## Noise Impact Statement

**A NOISE IMPACT STATEMENT**

**RE: ADDENDUM TO THE ACOUSTIC REPORT "A NOISE IMPACT STATEMENT"**

ERM was engaged to undertake a technical review of the noise barrier design and improve the graphics of the report entitled "A Noise Impact Statement, for the Proposed Residential Development at Moonee NSW, Revision 1" dated 4 January 2006.

**Figure 1**  
**2005, dB(A), L<sub>eq</sub> 15Hrs**

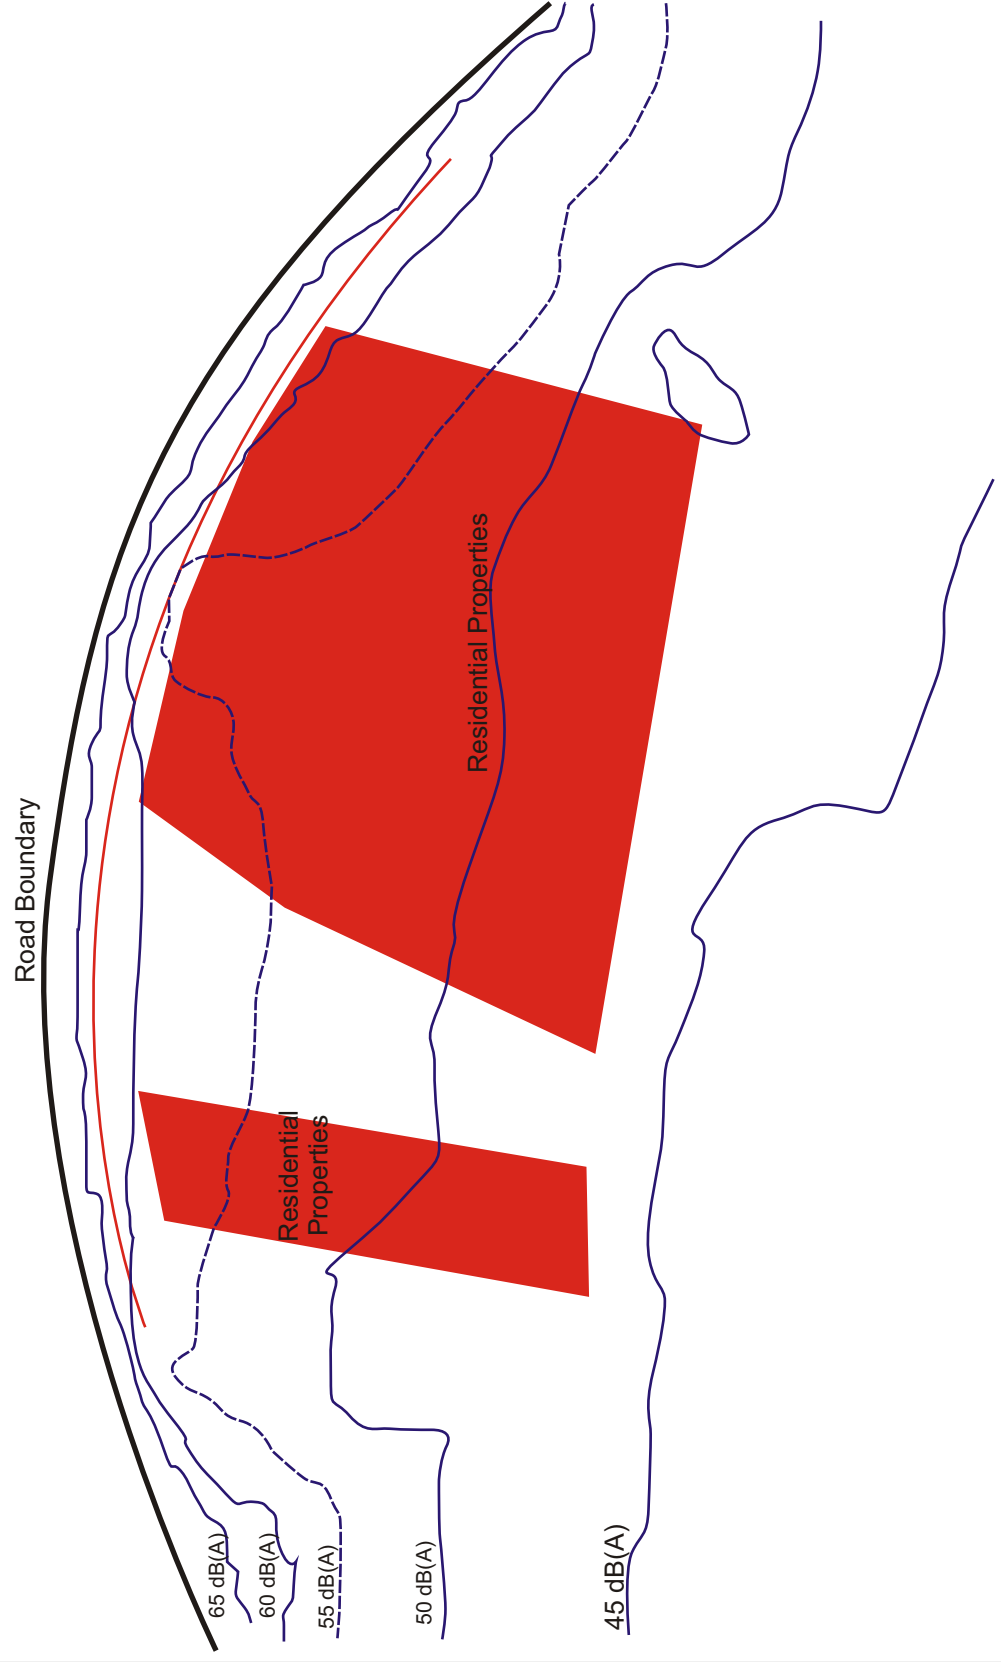
Calculations indicate that the barrier attenuations noted in the report are appropriate. As stated in the report some residential lots will require building façade design in conjunction with the noise barriers to ameliorate road traffic noise from the Pacific Highway. Based on *Figure 6* and *Figure 8* in the report, it is recommended that houses on lots 1-4, 13-19, 22, 85 & 86 be acoustically treated. These lots will also require mechanical ventilation and should be designed with noise sensitive rooms facing away from the Pacific Highway (such as bedrooms and living rooms) and noise insensitive rooms facing the Pacific Highway (such
